Replies to the Interactive Discussion on "A paradigm of extreme rainfall pluvial floods in complex urban areas: the flood event of 15 July 2020 in Palermo (Italy)."

RC1: 'Comment on nhess-2021-61', Anonymous Referee #1, 14 Apr 2021

Title: A paradigm of extreme rainfall pluvial floods in complex urban areas: the flood event of 15 July 2020 in Palermo (Italy)

MS No.: nhess-2021-61

Figure 9. Rainfall Discharge obtained from the hydrological simulations in TOPDM. The bars in the upper part of the figure indicate the IDW interpolated precipitation over the four basins.

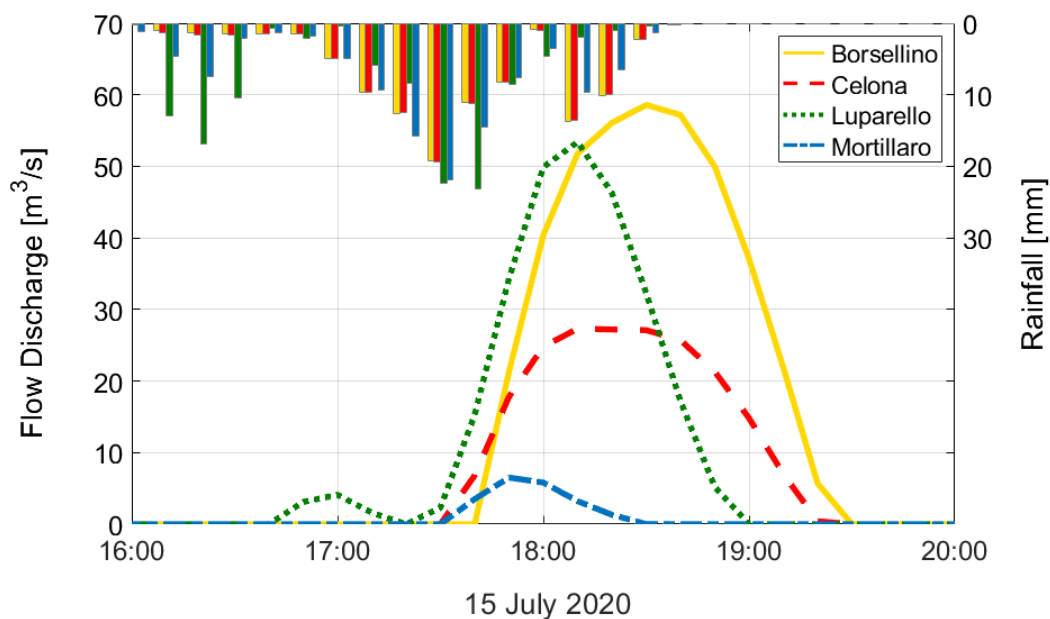
Referee: Figure 10. lines in legend are blurry.

Response: We thank the Referee for pointing this out. We have corrected the legend of the Figure 9 (Figure 10 in the old version of the manuscript). For the Referee’s convenience and information, we have reported here the new Figure 9.
